Change Order #2

Regional Linear Park Phase II (Hike & Bike Trail)

Owner: Hidalgo County Precinct #2

Project: RLPPII
Contract: C-18-199-02-12
CSJ: 0921-02-409
Limits: Hall Acres to Ridge Road

REGIONAL LINEAR PARK PROJECT
 US 281 (S. CAGE RD.)
 DETOUR LAYOUT

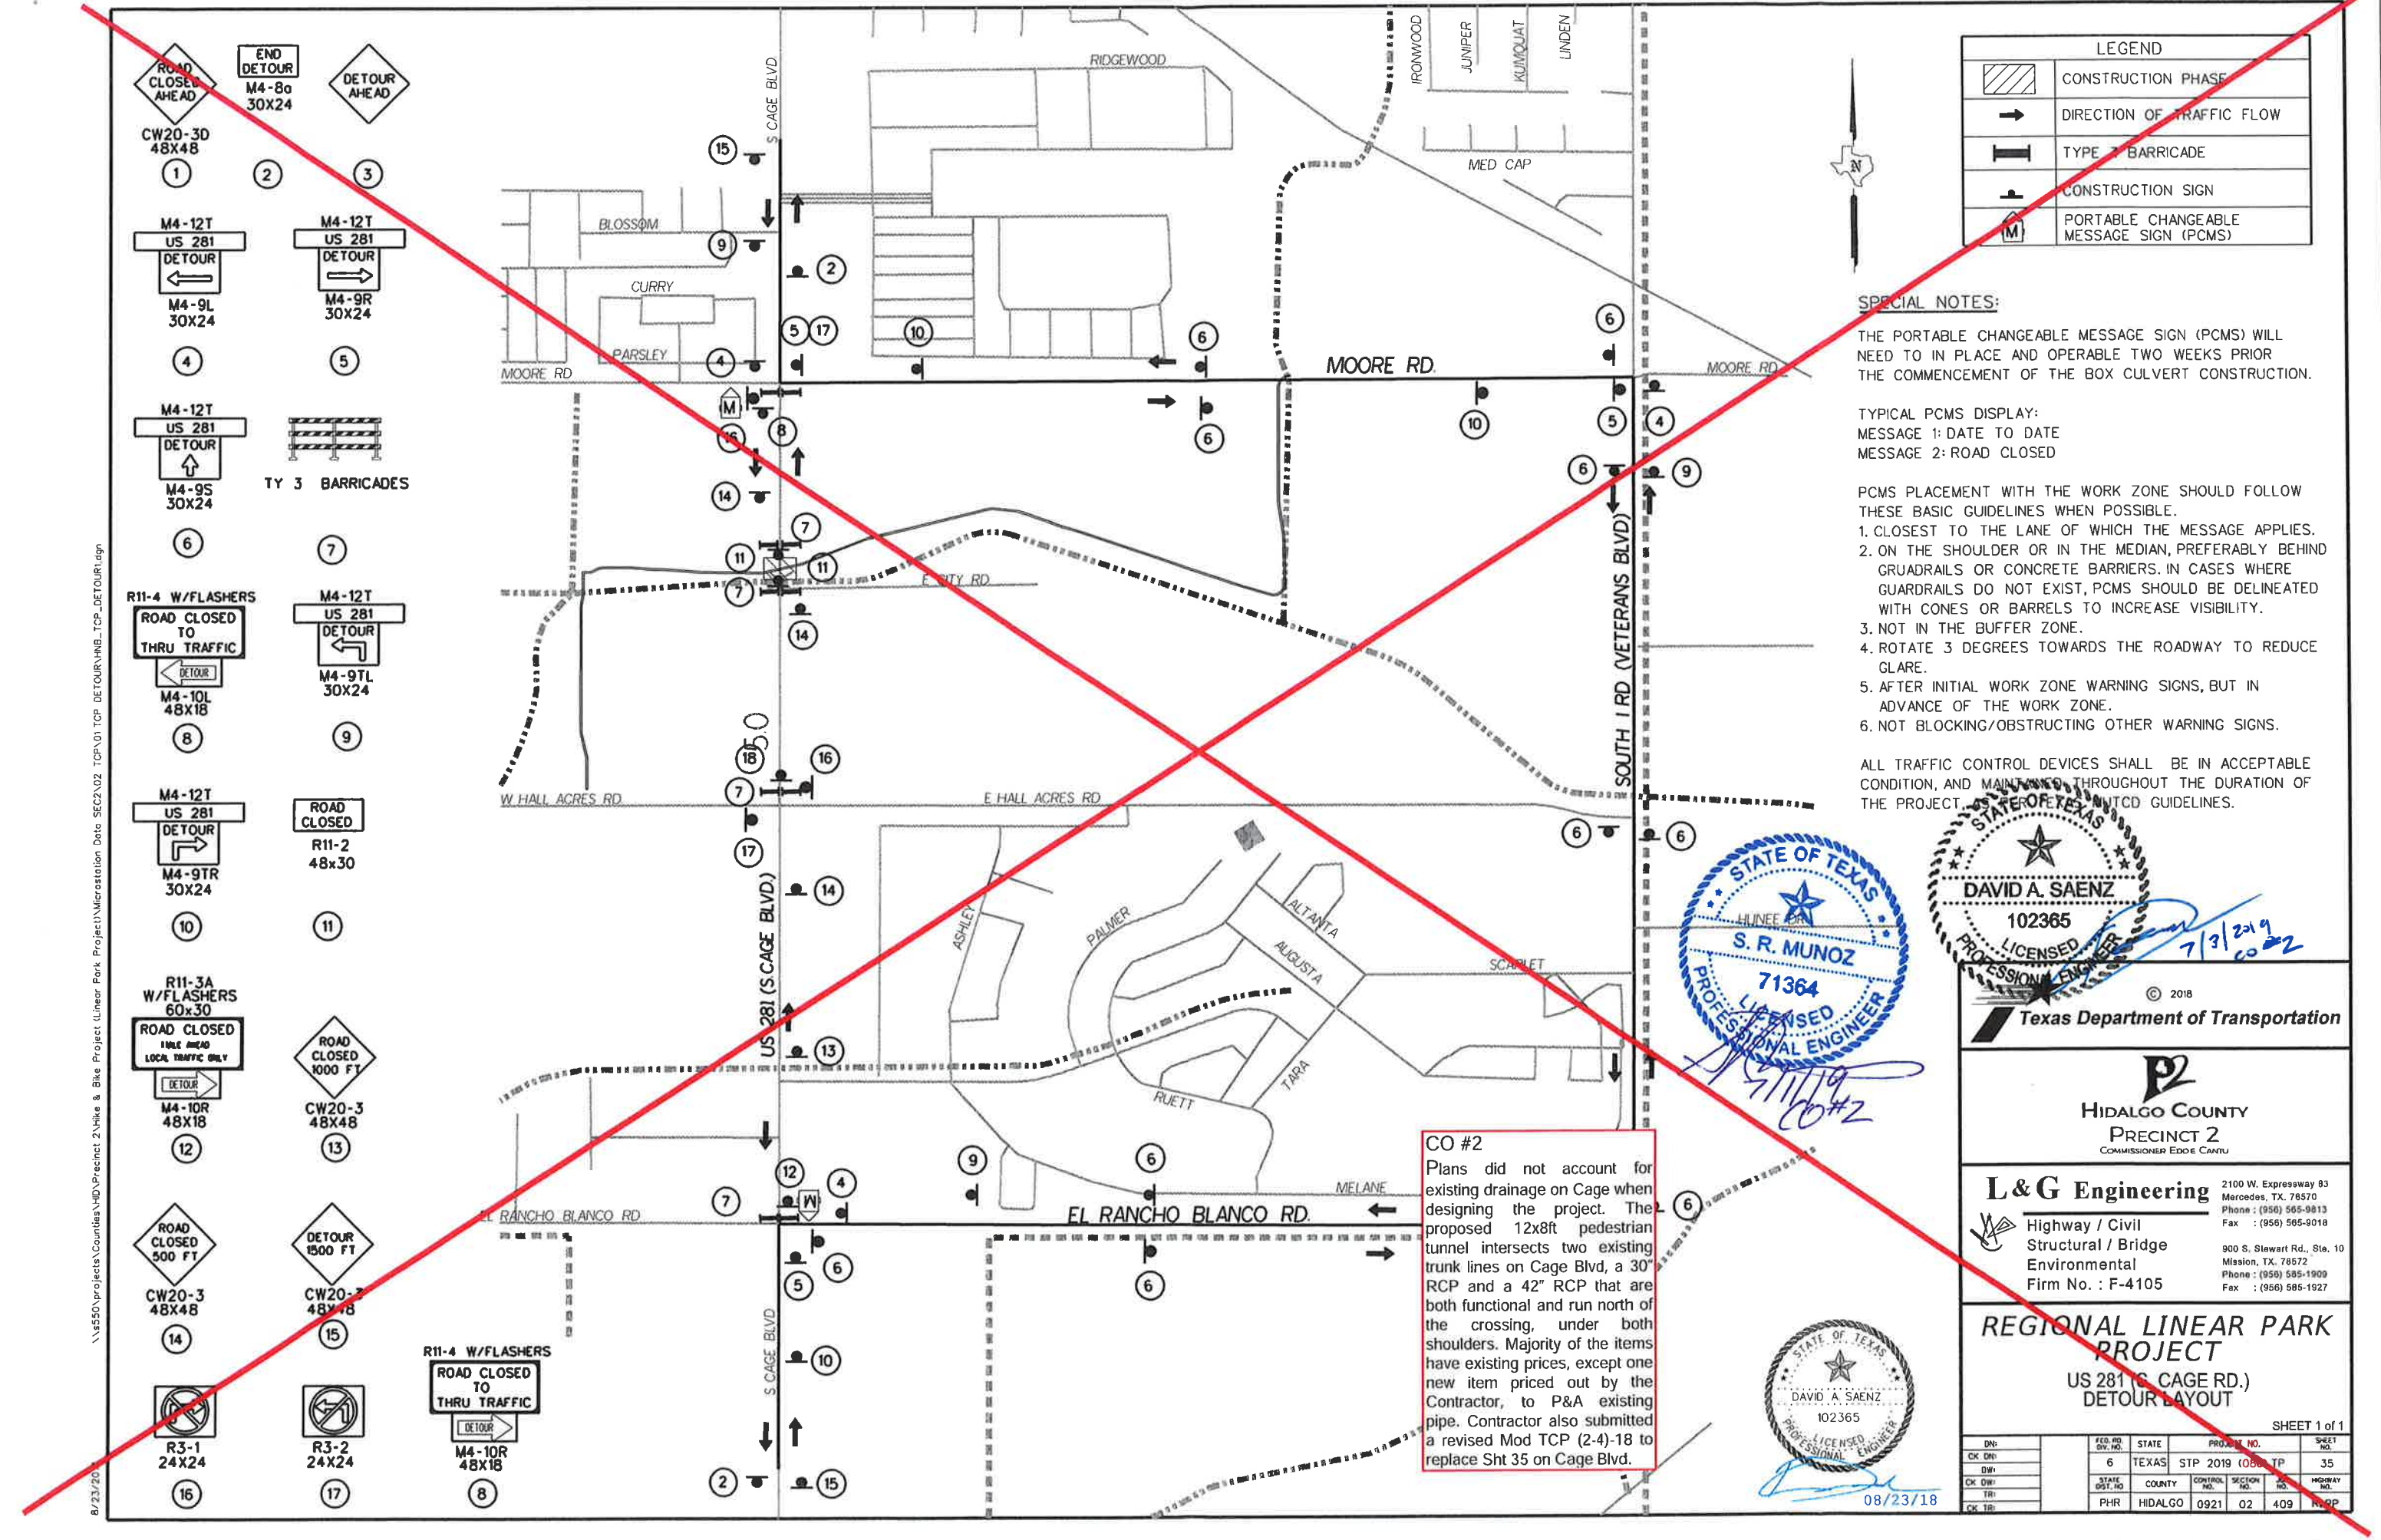
CO #2
 Plans did not account for existing drainage on Cage when designing the project. The proposed 12x8ft pedestrian tunnel intersects two existing trunk lines on Cage Blvd, a 30" RCP and a 42" RCP that are both functional and run north of the crossing, under both shoulders. Majority of the items have existing prices, except one new item priced out by the Contractor, to P&A existing pipe. Contractor also submitted a revised Mod TCP (2-4)-18 to replace Sht 35 on Cage Blvd.

MOD TCP(2-4)-18

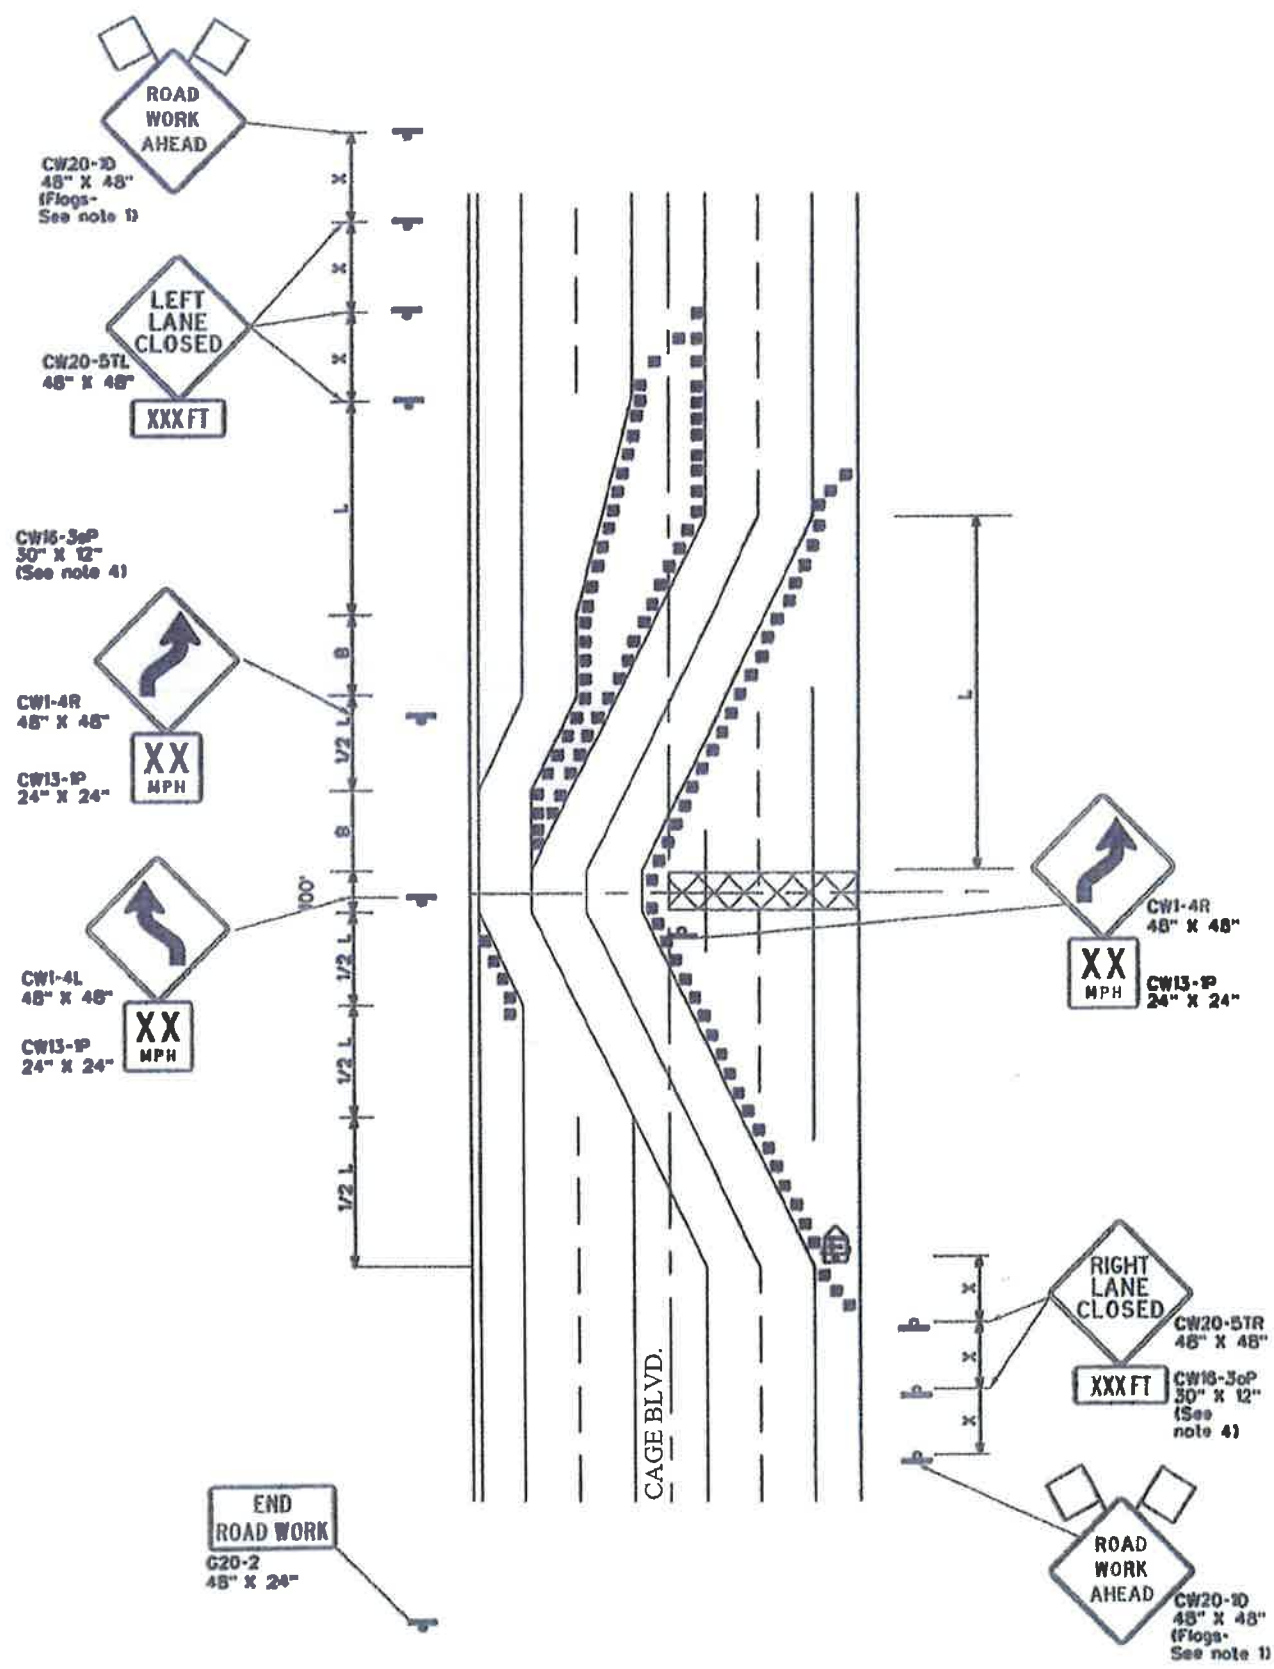
CO #2
 Plans did not account for existing drainage on Cage when designing the project. The proposed 12x8ft pedestrian tunnel intersects two existing trunk lines on Cage Blvd, a 30" RCP and a 42" RCP that are both functional and run north of the crossing, under both shoulders. Majority of the items have existing prices, except one new item priced out by the Contractor, to P&A existing pipe. Contractor also submitted a revised Mod TCP (2-4)-18 to replace Sht 35 on Cage Blvd.

Y. Corbett, PE
 5/24/2019
 CO#2

CO #2 Quantities

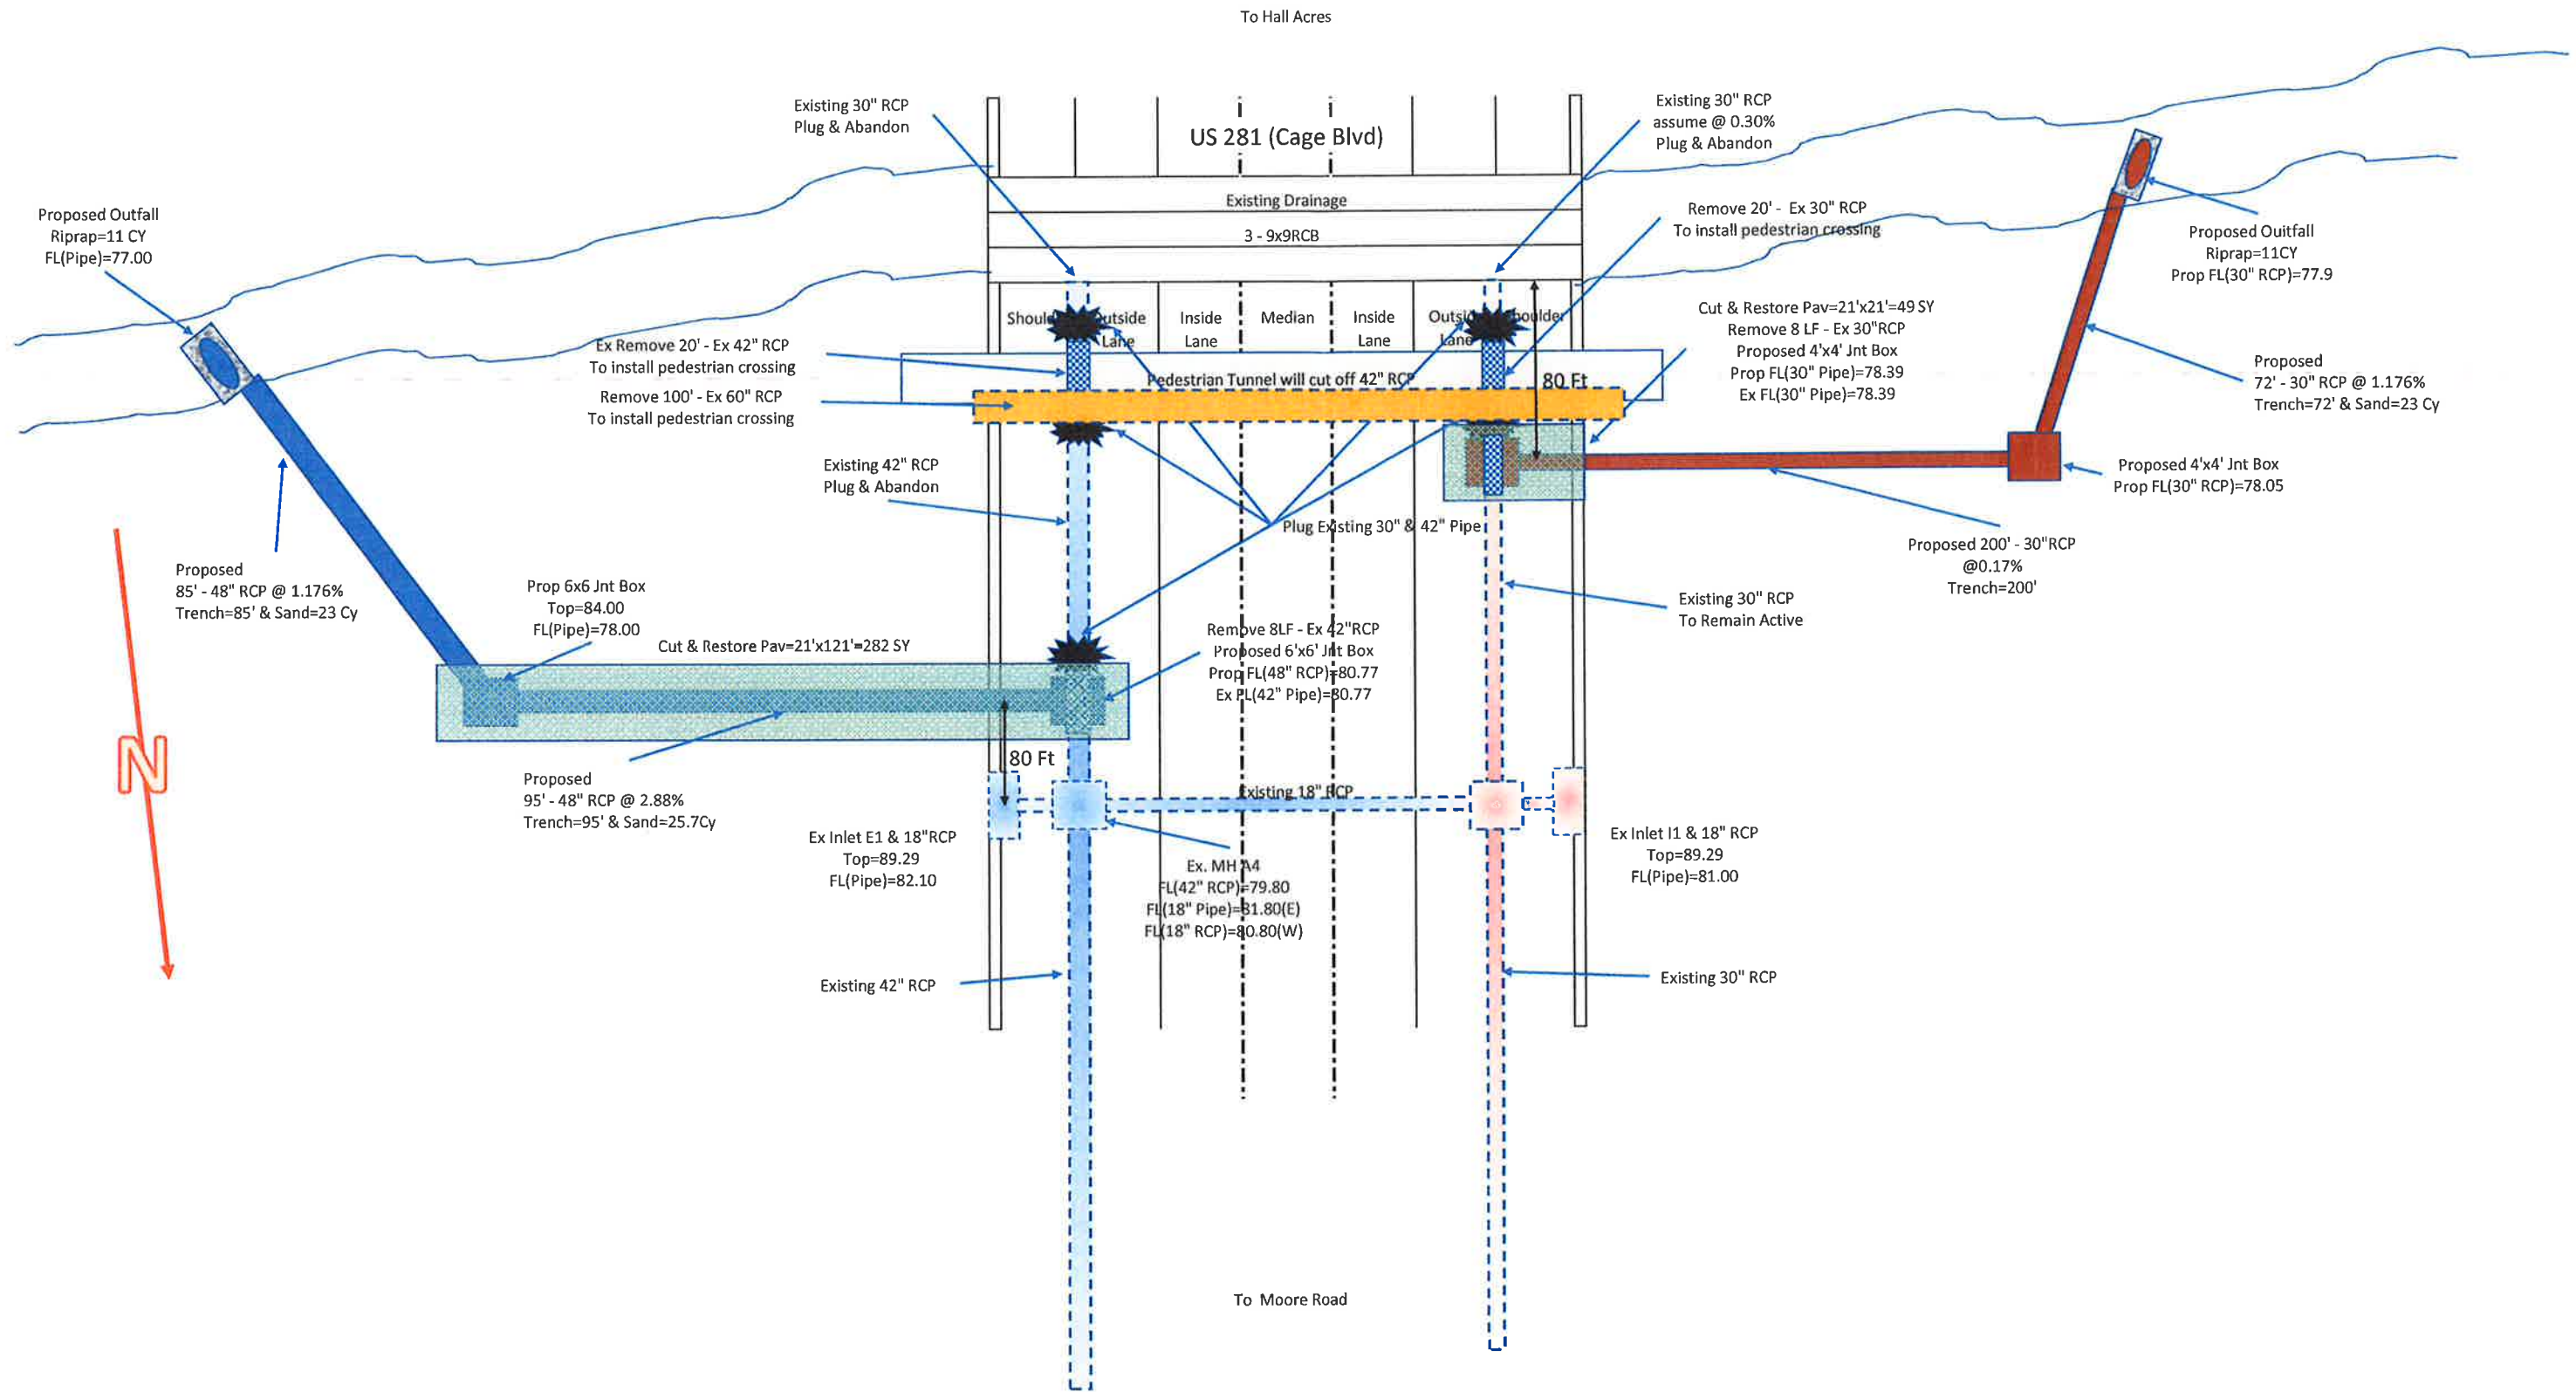
Pedestrian Tunnel will cut off 42" RCP

Ex Remove 20' - Ex 42" RCP
To install pedestrian crossing
Remove 100' - Ex 60" RCP
To install pedestrian crossing

Existing 30" RCP
assume @ 0.30%
Plug & Abandon

Remove 20' - Ex 30" RCP
To install pedestrian crossing

Proposed
85' - 48" RCP @ 1.176%
Trench=85' & Sand=23 Cy

Prop 6x6 Jnt Box
Top=84.00
FL(Pipe)=78.00

Proposed
95' - 48" RCP @ 2.88%
Trench=95' & Sand=25.7Cy

Cut & Restore Pav=21'x21'=49 SY
Remove 8 LF - Ex 30" RCP
Proposed 4'x4' Jnt Box
Prop FL(30" Pipe)=78.39
Ex FL(30" Pipe)=78.39

Proposed 200' - 30" RCP
@0.17%
Trench=200'

Proposed
72' - 30" RCP @ 1.176%
Trench=72' & Sand=23 Cy
